Re: PLANO ZONING CASE #2022-003

Response to Medical City of Plano's Zoning Exhibits and Explanations

Aspen Court Apartment's Response to Medical City Plano's Zoning Exhibits and Explanations

*Evaluation
of the
Proposed Rooftop Heliport
At
Medical City of Plano*

SHADE & SHADOWS:
DATE: FEBRUARY 14
TIME: 4:30 PM

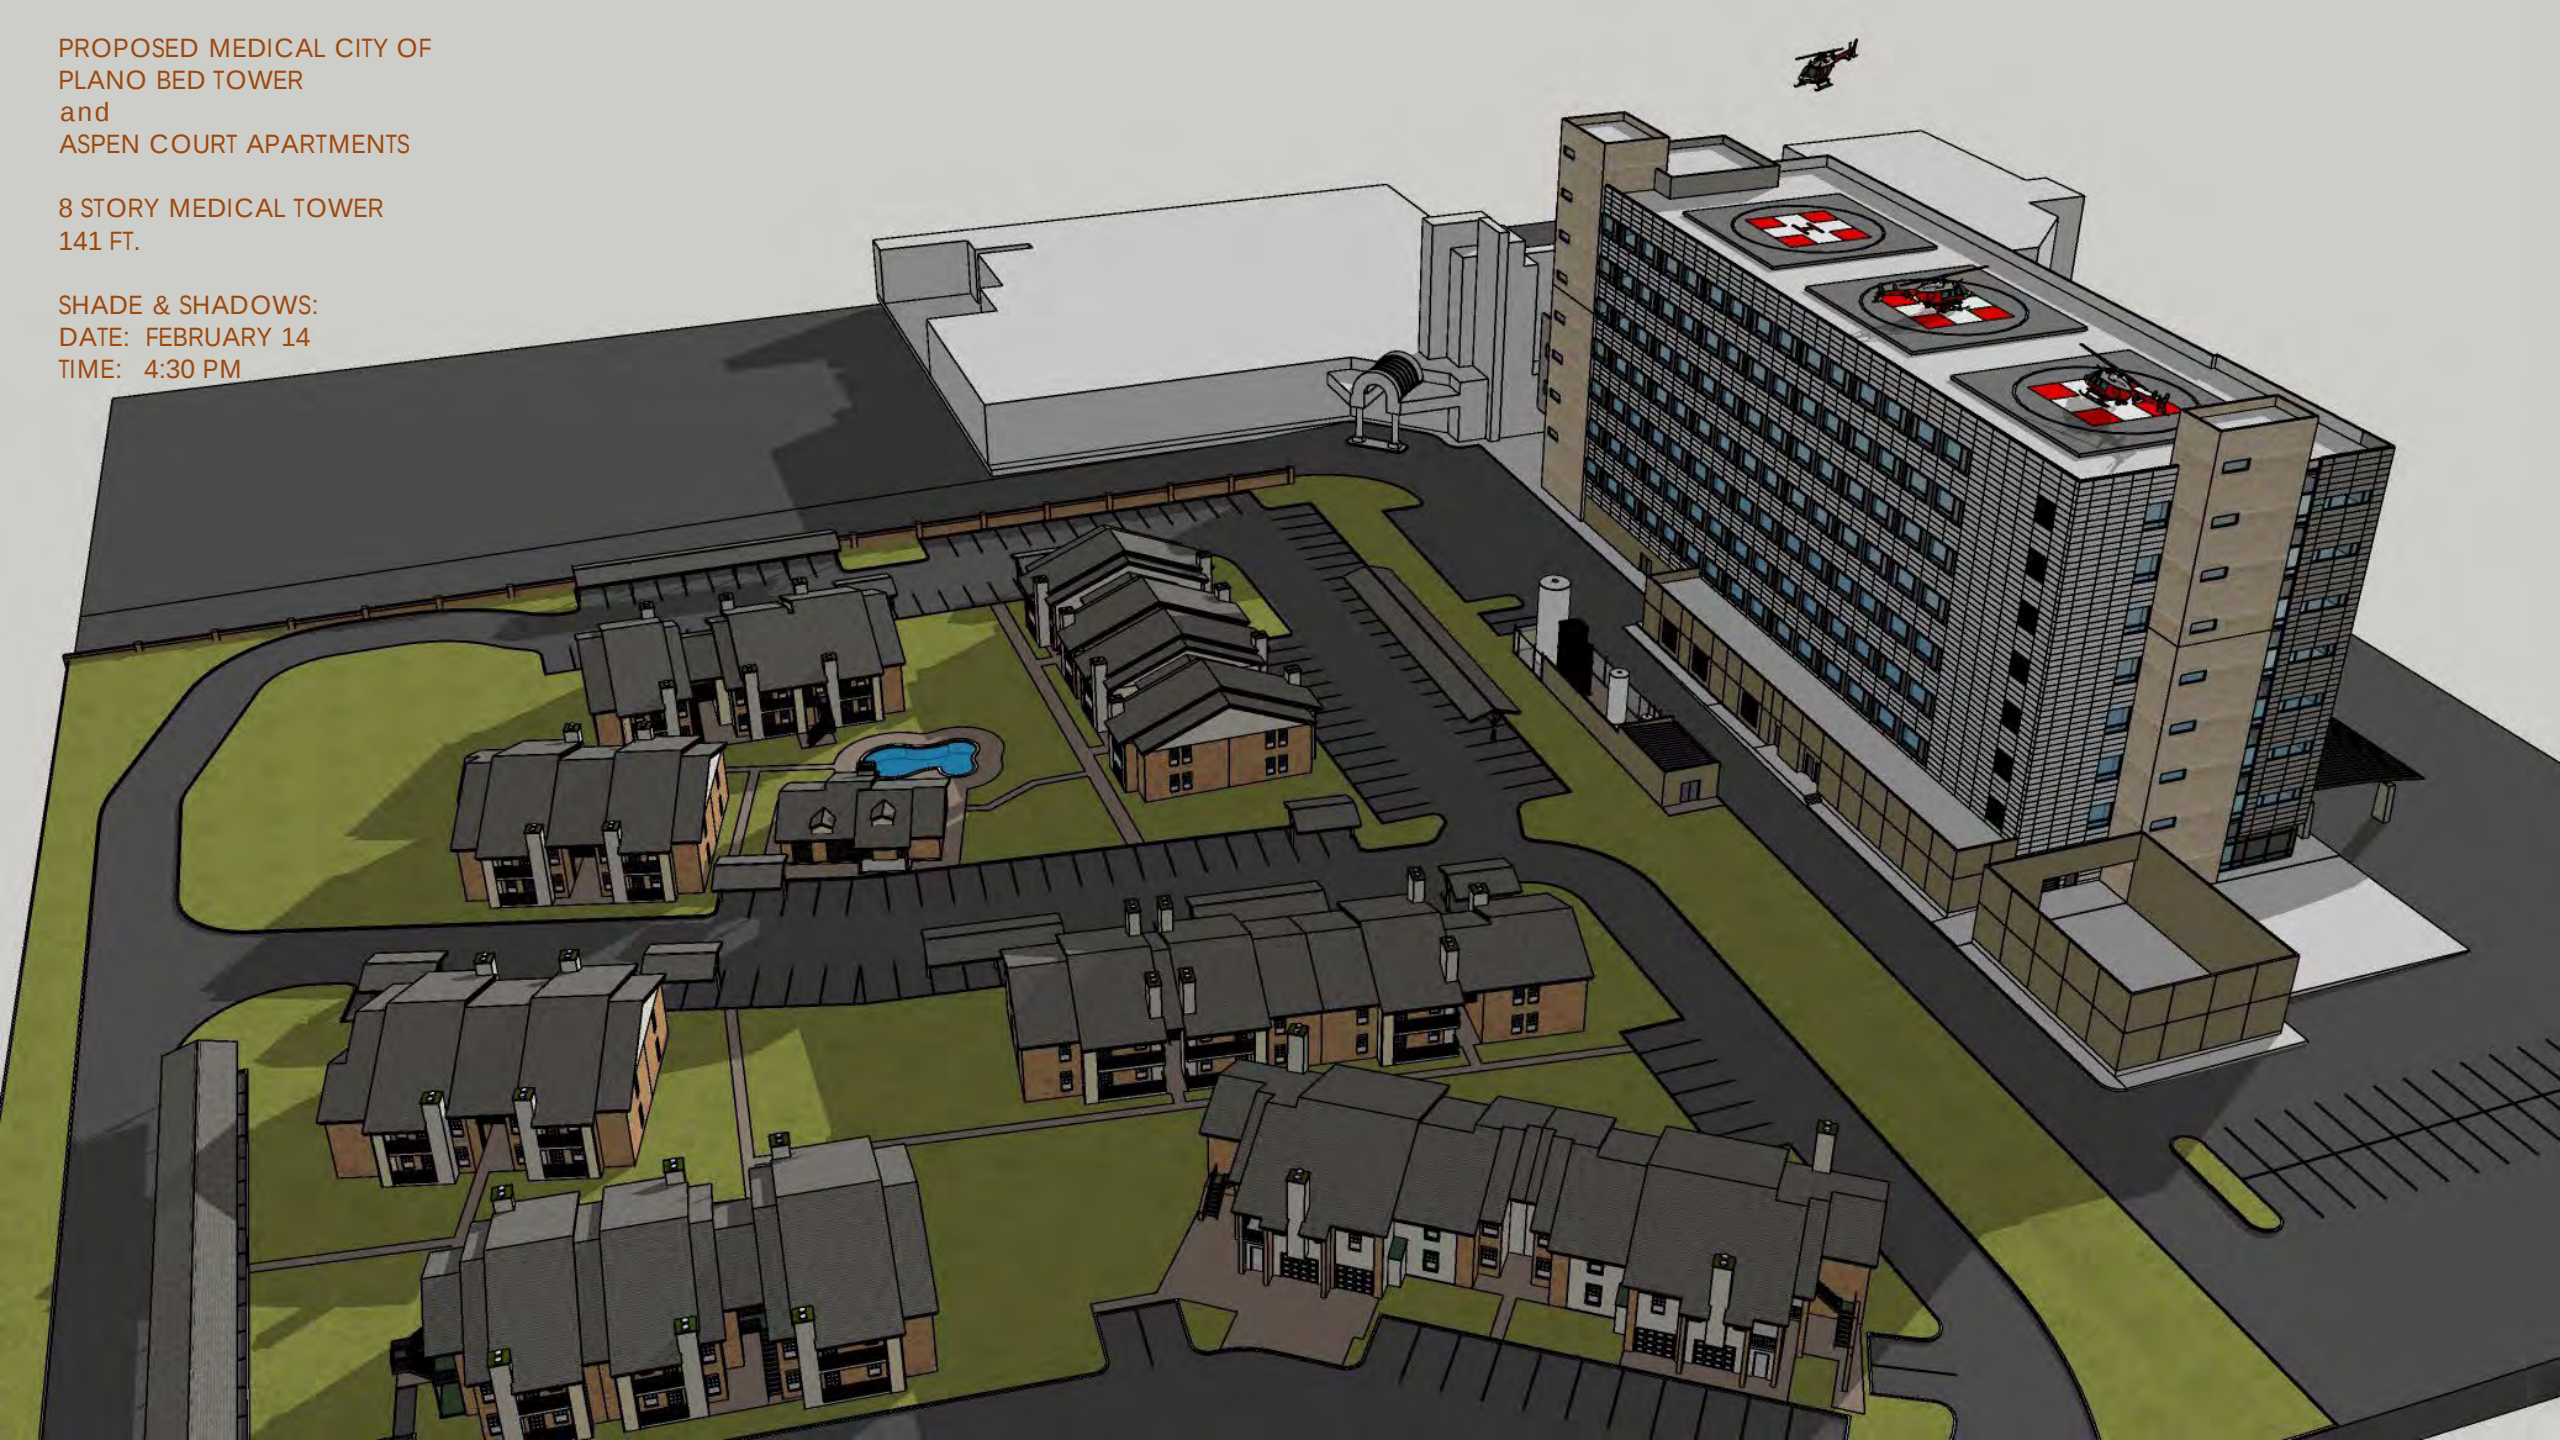
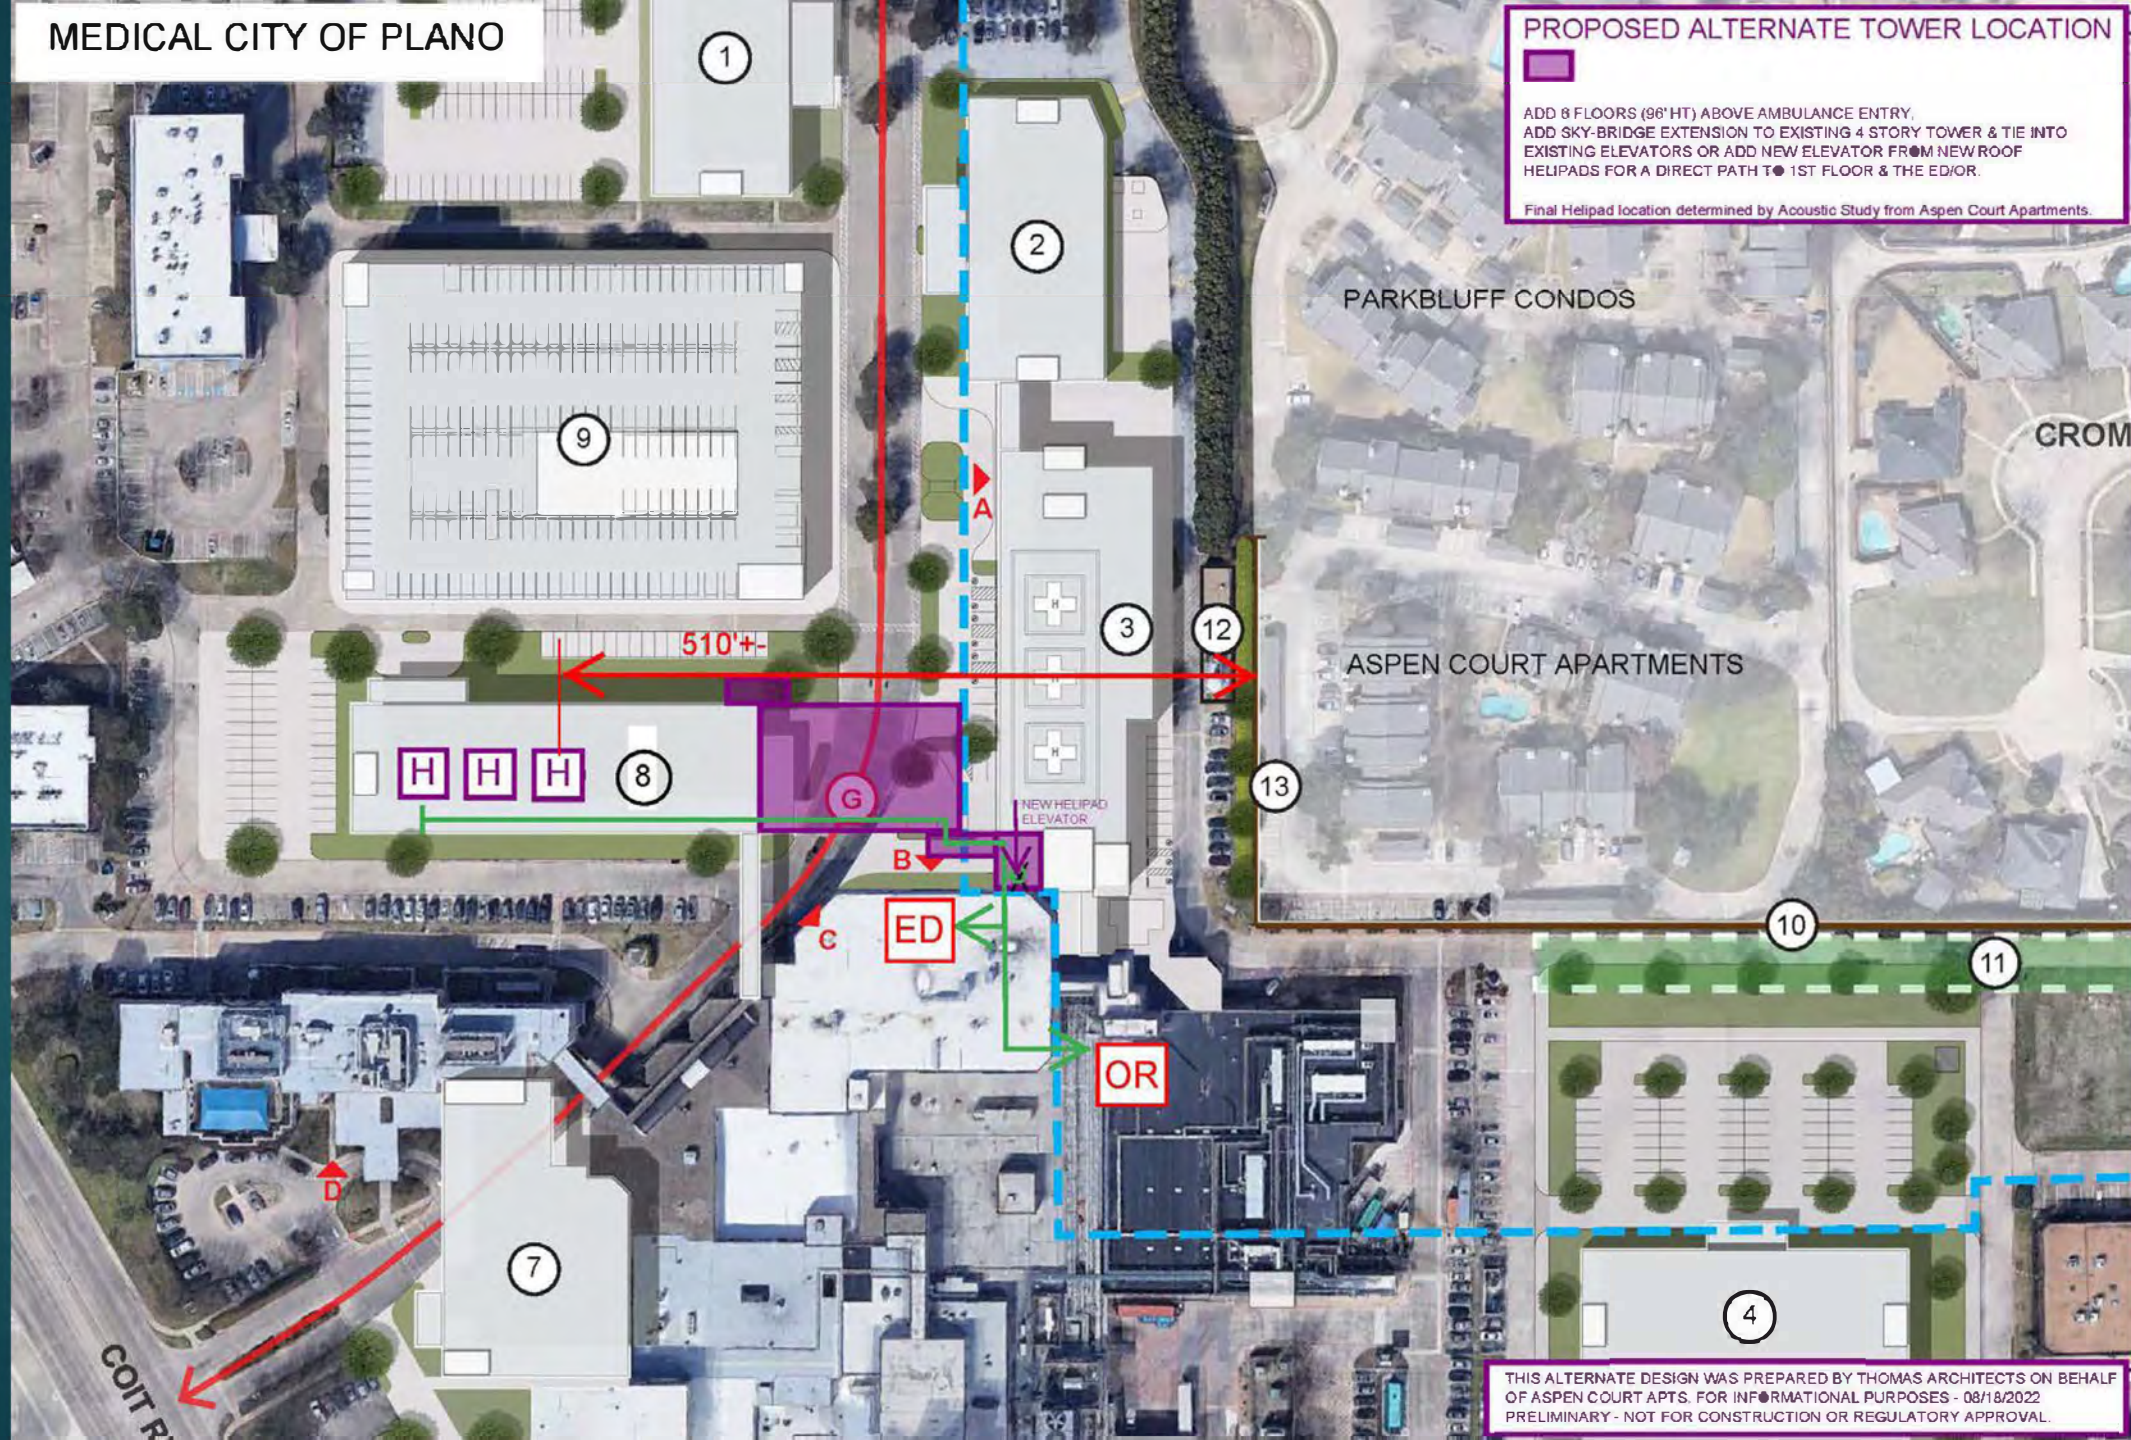
C Tower expansion (adding 4 floors to existing 4-stories) - The Solar/Shadow Study submitted by MCP measures 5 days in the year, covering every season, "and identified limited impact of shadows on the apartment complex". Shadow Study submitted on behalf of Aspen Court was "based on one day of the year in February, with shortest duration of sunlight". These two statements are false and misleading.

MCP issued a false statement regarding February 14th (Aspen Court Shadow Study date) as having the shortest duration of sunlight (sunrise at 7:11 AM and sunset at 6:11PM). Actually, the shortest day of the year occurs on December 21st (sunrise at 7:25 AM and sunset at 5:24PM) per MCP's own Solar/Shadow Study prepared by Perkins and Will. Aspen Court Apartment's color 3-D Shadow Study demonstrates shadows cast on $\frac{3}{4}$ of the property during late afternoons-evenings. However, due to the height of the proposed 8 story tower, with only an 85' setback to the Aspen Court property line will cause the entire west horizon to be visually blocked to Aspen Court's residents.

Moreover, it serves no purpose for the MCP Solar/Shadow Study to include shadows cast at 9:00 AM, 12:00PM and 3:00PM in the afternoon when it is obvious shadows across Aspen Court don't exist. Using a 5:00PM Shadow Study as the latest time period year round by Perkins and Will is misleading as sunsets are as follows per the MCP Study: March 21st -7:39PM, June 21st -8:38PM and September 21st - 7:24PM. It would be more meaningful for their study to include Shadow Studies at 6:00PM to 7:00PM for the previous cited time periods during evening hours when most residents are home.

2. **Shadows cast across Aspen Court by the 8-story C Tower** will cause early night fall for Aspen Court residential units year round due to shadows cast across Aspen's buildings, particularly after 5:00PM. The setback for C Tower is more akin to a 2-story building versus an 8-story structure. The result will be the loss of view toward the western horizon for all residents.

Figure 1
Proposed Building and Distances from Homes

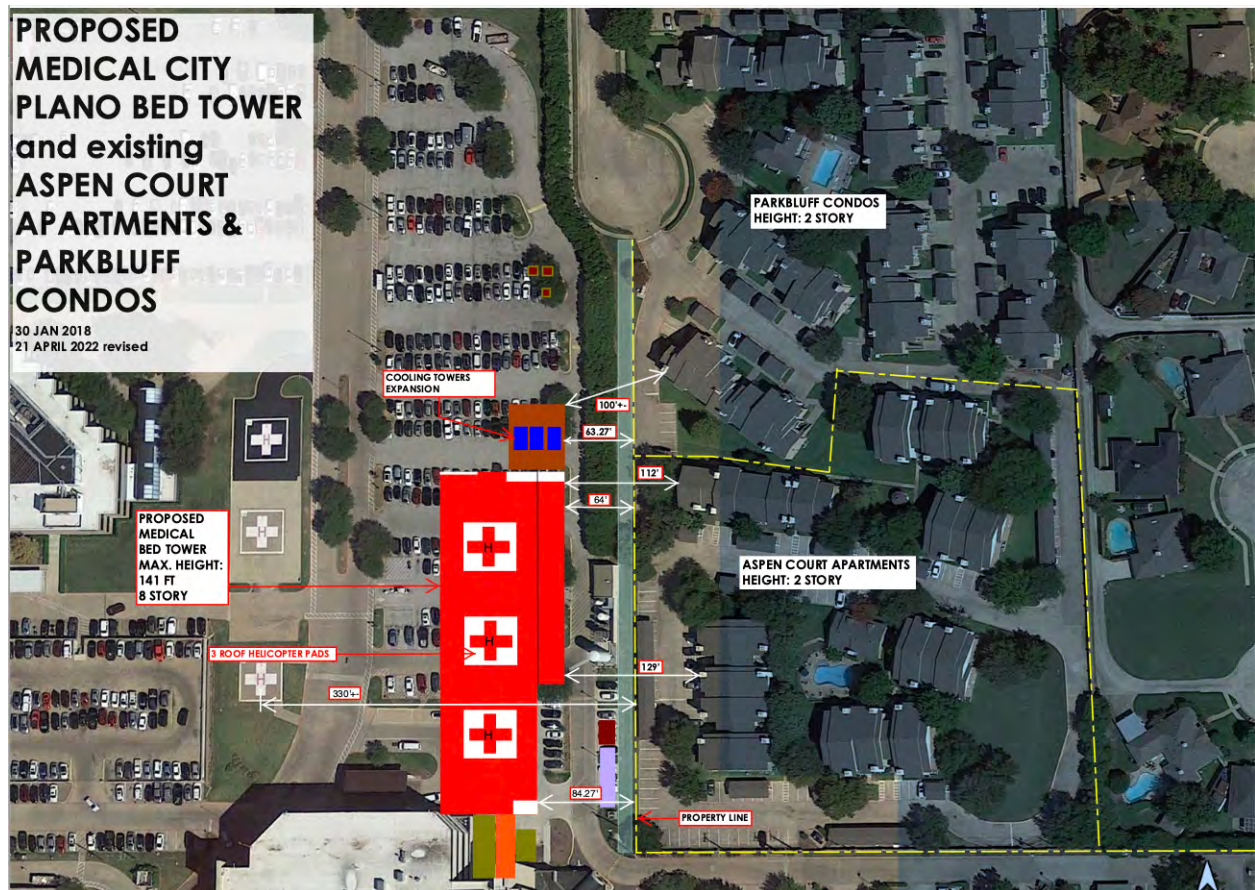
Medical City of Plano is proposing to build an eight-story parking structure on top of which it will build a heliport with three landing pads. The structure of the proposed building will be 84.4 feet from the property line of Aspen Court Apartments and 112 feet from the wall of the closest apartment.

In the photograph (*Figure 1*) below which has the proposed building and rooftop heliports, one can see the proximity of the new heliport to homes and apartments and the actual distances to them. The property line is 84.4 feet from the existing building and the apartments are 100 feet from the cooling tower expansion and 112 feet from the existing building that Medical City wishes to extend upwards. The heliports in the diagram are easily identifiable by the white cross.

*Figure 5
FAA Recommended Glide Paths*

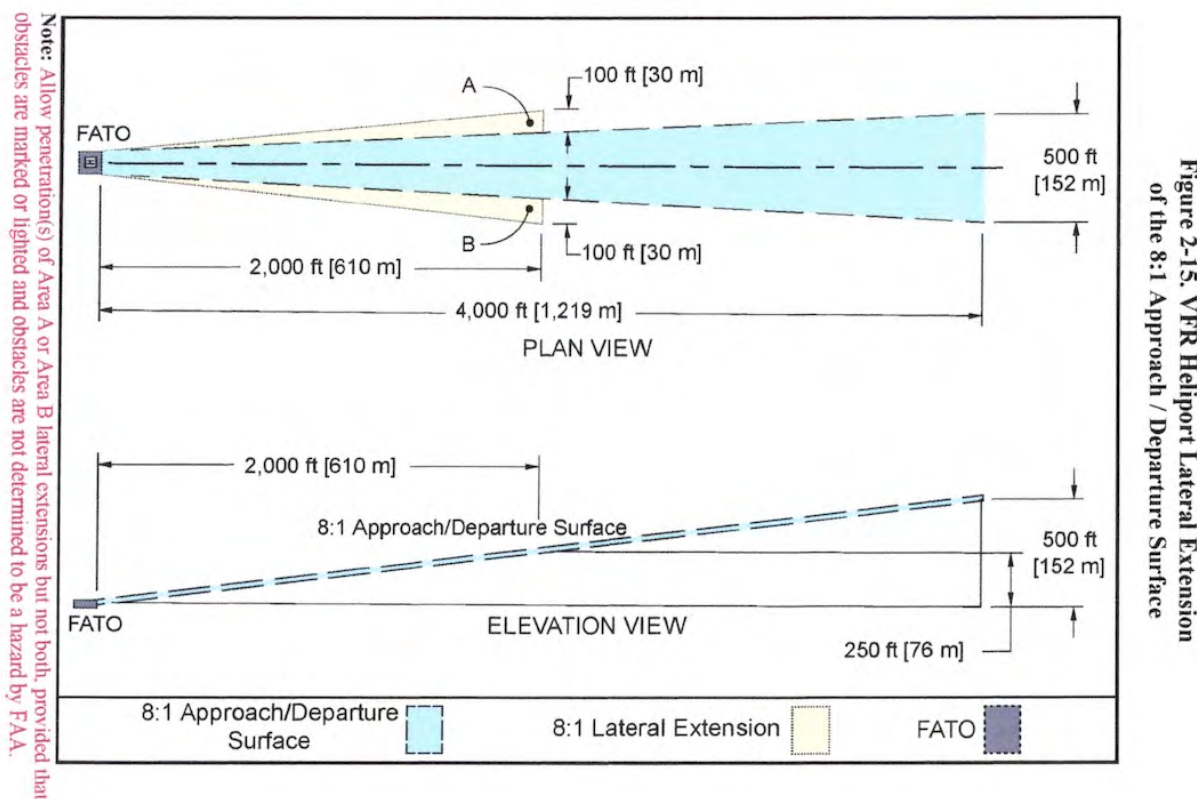
Figure 5 was taken from the FAA Advisory Circular AC 150/5390-2D and shows the clearance recommended by the agency. For a heliport 125 feet in the air, the proposed heliport meets the clearances if approaching from the east or west. However, due to the width and height of the combined elevator shaft and stairwell towers, the heliport as proposed *does not* meet the FAA's requirements.

As noted in Section 5.1, the FAA recommends no obstacles on either side of the centerline. These combined stair wells and elevator shafts are within what the FAA denotes as the safety zone and do not allow a straight in approach. The FAA acronym FATO is short for “final approach to a hover.”

Figure 10
Noise Footprints Approaching from the East

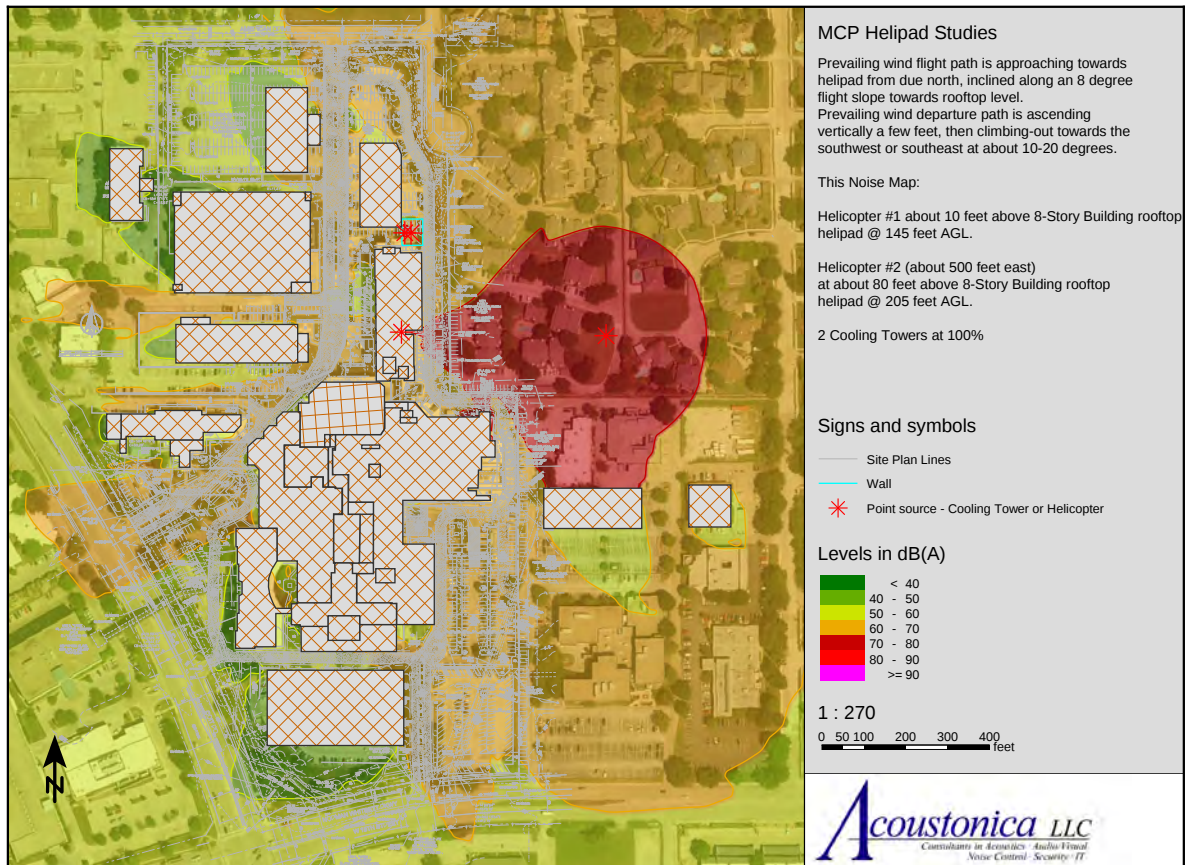
Figure 10 shows the noise footprint and noise levels of a helicopter approaching the heliport from the east and descending from 205 feet above the ground. When it does this, residents of Aspen Court Apartments, Park Bluff and Amelia Court will be subjected to noise levels of between 80 and 90 dB. This is 15 -25 dB above and significantly higher than the City of Plano ordinance limits of 65 dB during the day. If the flight nighttime is at night, it is 25 – 35 dB higher than allowed by the City of Plano's ordinance.
